**PROPOSED RESIDENTIAL DEVELOPMENT AT
CHASEWOOD MEADOW, FERNBANK ROAD,
ROSS-ON-WYE, HR9 5DH**

PLANNING APPLICATION P224260/F

APPEAL STATEMENT ON HIGHWAY MATTERS

December 2023

Drawing Title: Phase 1 Indicative Footpath Widening Layout

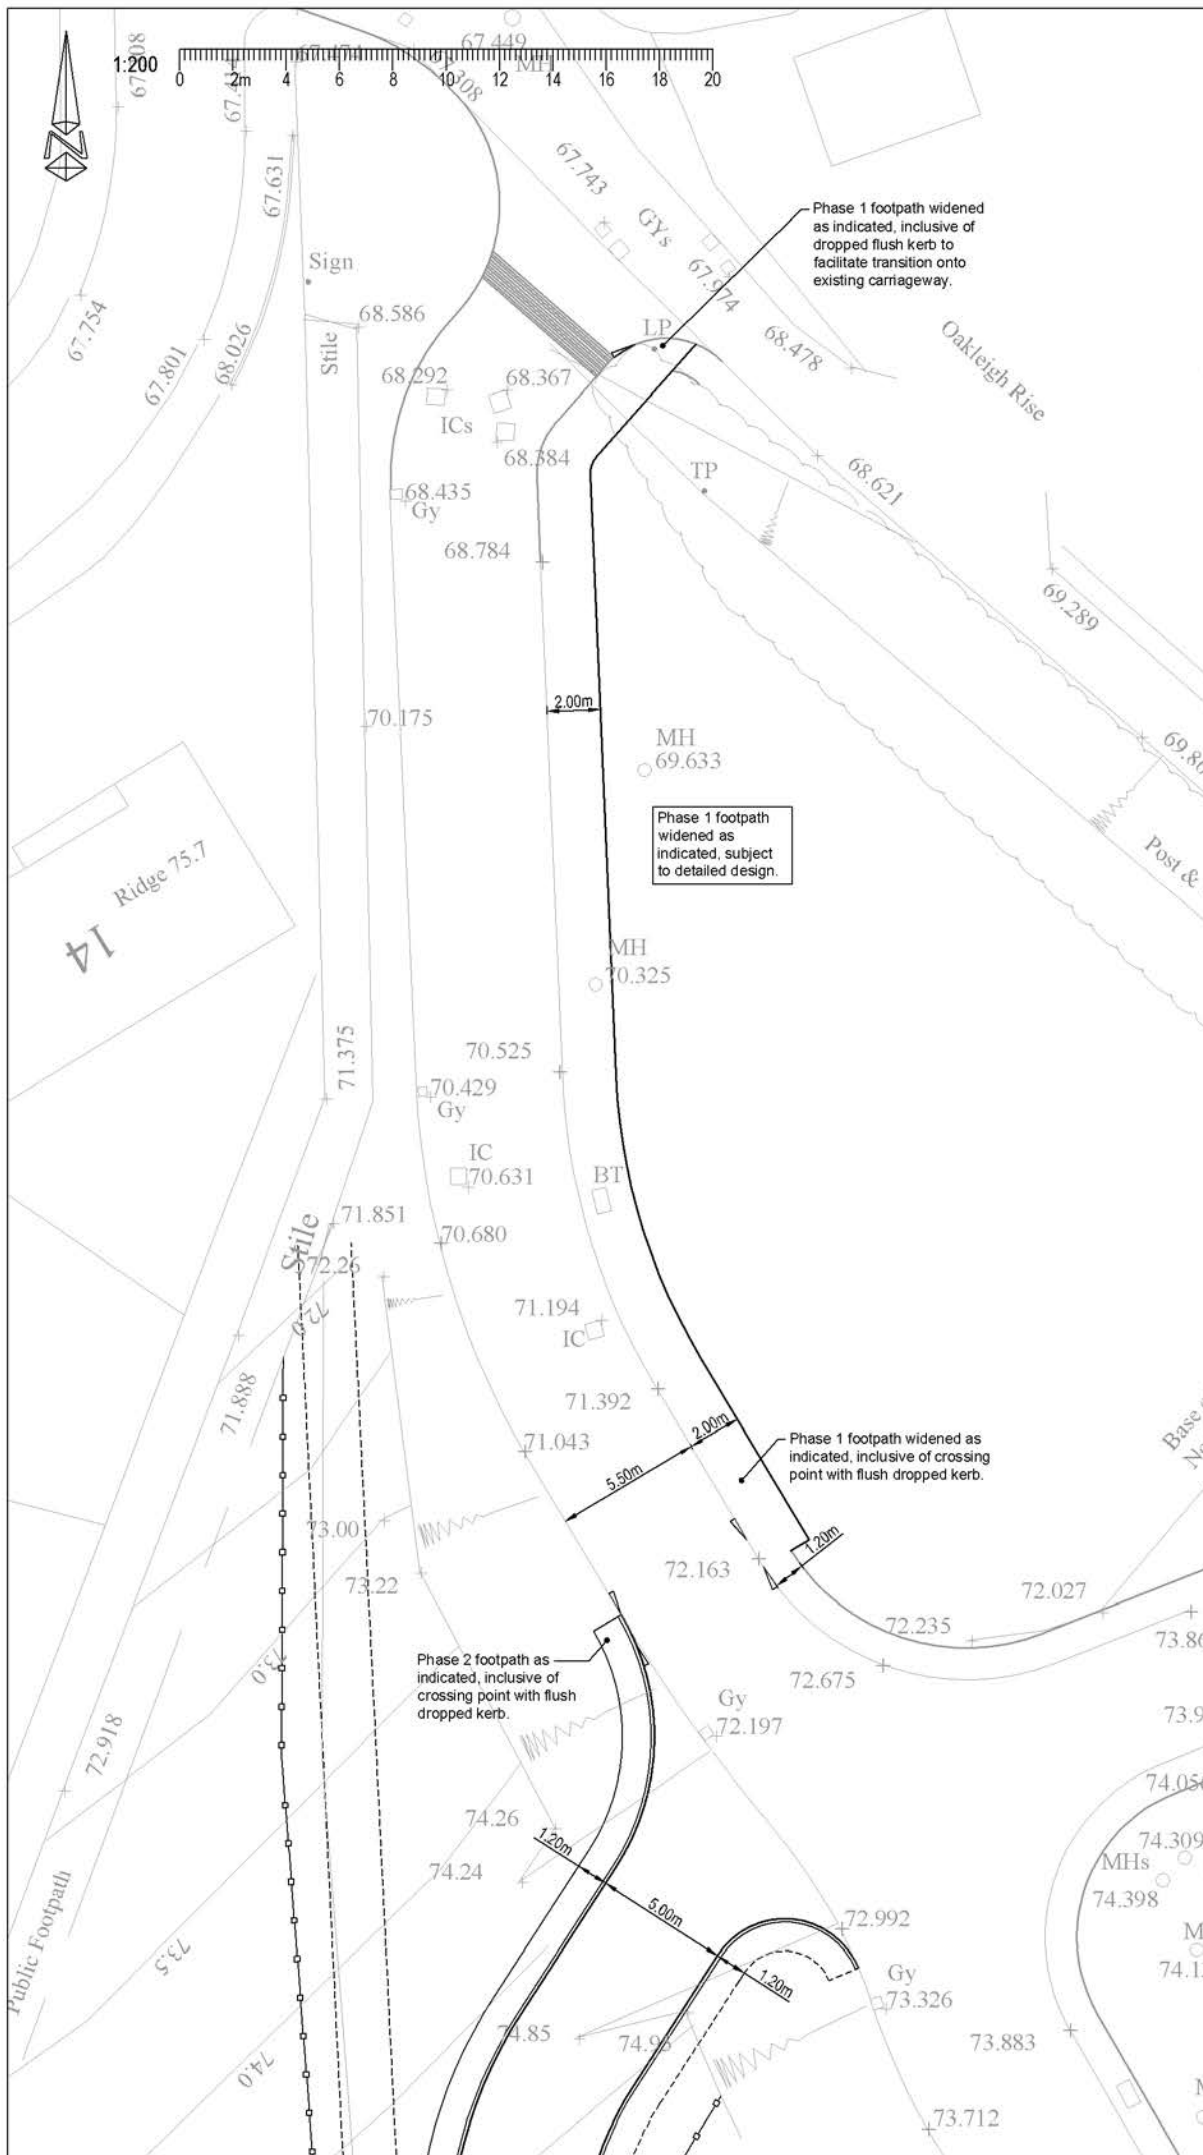
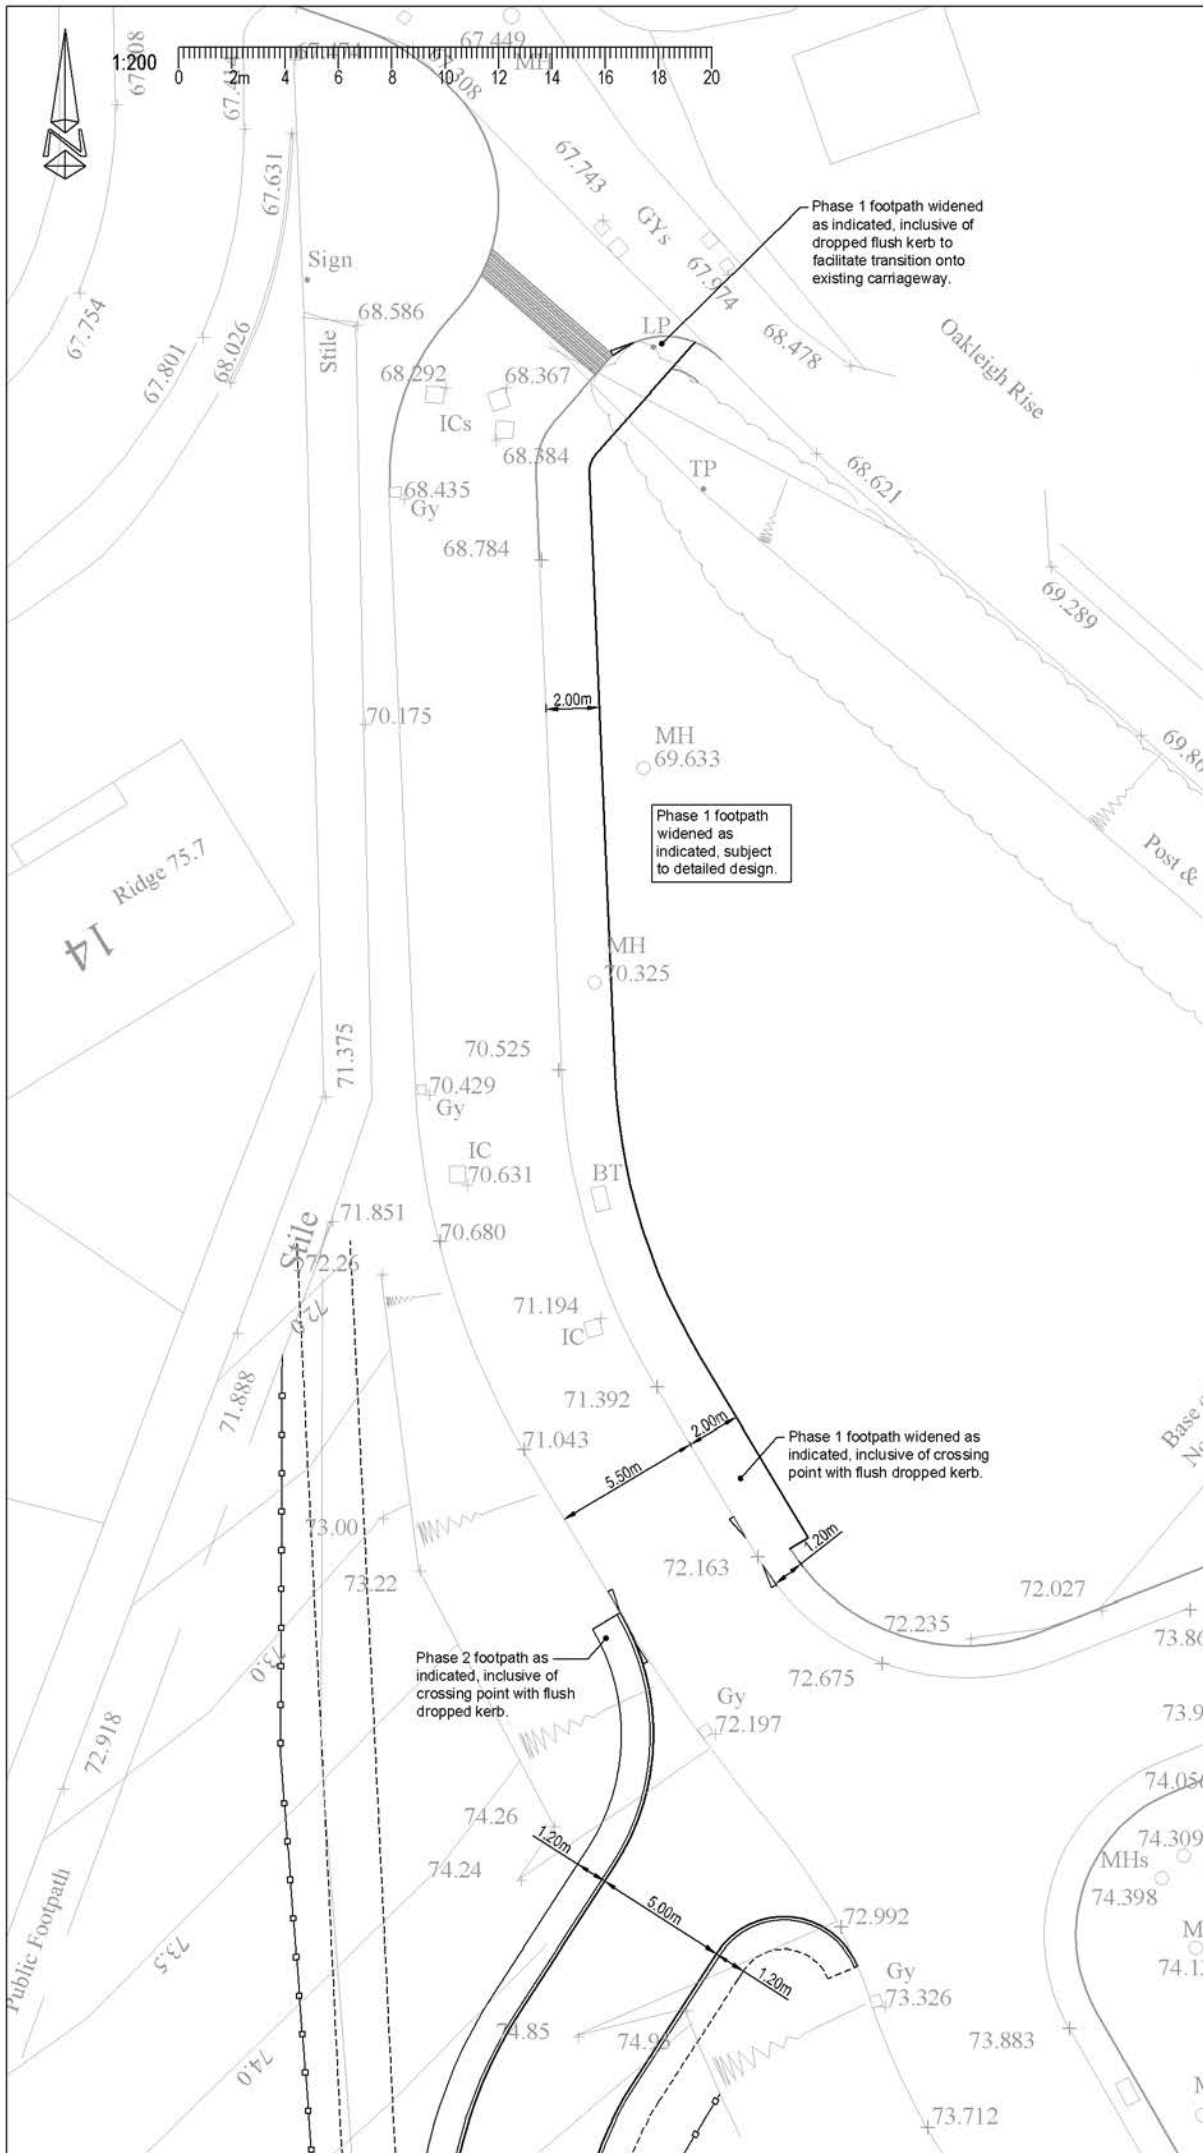
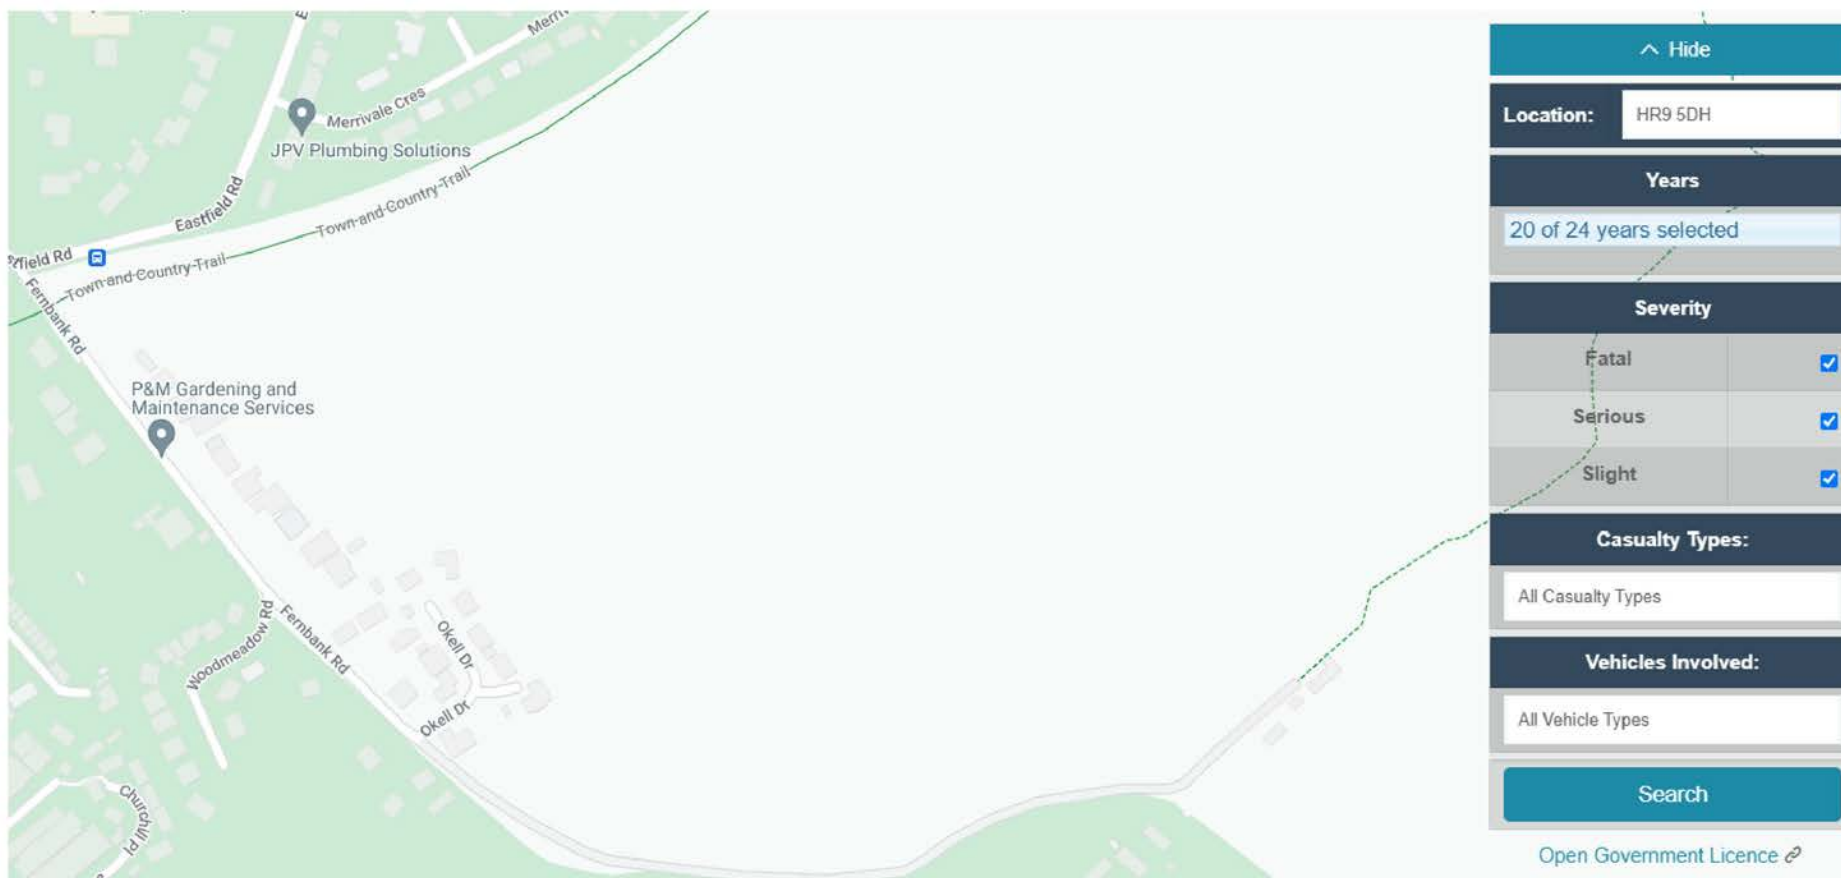
- 16.0 The Addendum also included further commentary and drawings associated with the design and detailing of the original access (phase 1). It confirmed that the principles within the Herefordshire Council design guidance were utilised while also considering the site-specific constraints and approved planning documentation. The various highway design elements were each considered individually, and detailed comments provided. The Addendum also acknowledged the approved visibility splays provided at the site access junction with Fernbank Road and confirmed the proposals for the provision of the requested widened footpath.

1. Demonstrate that the footway along Fernbank Road is not require by providing a Multi Modal assessment.
2. Are there any proposals to extend the site further than this additional 5 dwellings?
3. Can you provided details to show that the original site access meets HC design guidance.

3. Can you provide details to show that the original site access meets HC design guidance. – Please refer to our commentary and drawings attached addendum report.
